# PLANNING CLEARANCE

BLDG ADDRESS 2389 Mariposa Dr.

**► APPROVAL FOR BUILDING PERMIT ◀**  
**Ridges Architectural Control Committee (ACCO)**

2389 Mariposa Dr.

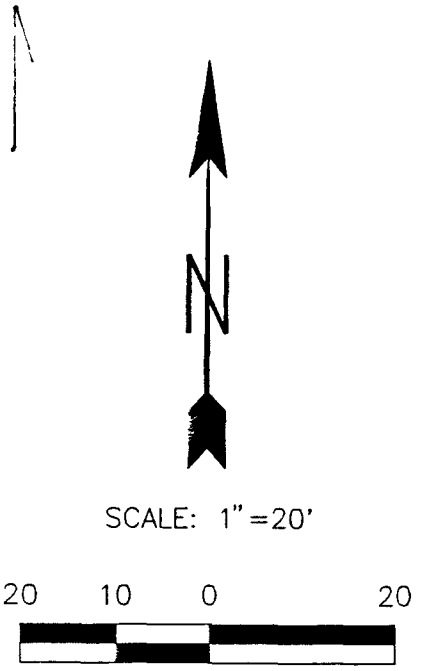
ACCEPTED KP 8/16/94  
 ANY CHANGE OF SETBACKS MUST BE APPROVED BY THE CITY PLANNING DEPT. IT IS THE APPLICANT'S RESPONSIBILITY TO PROPERLY LOCATE AND IDENTIFY EASEMENTS AND PROPERTY LINES.
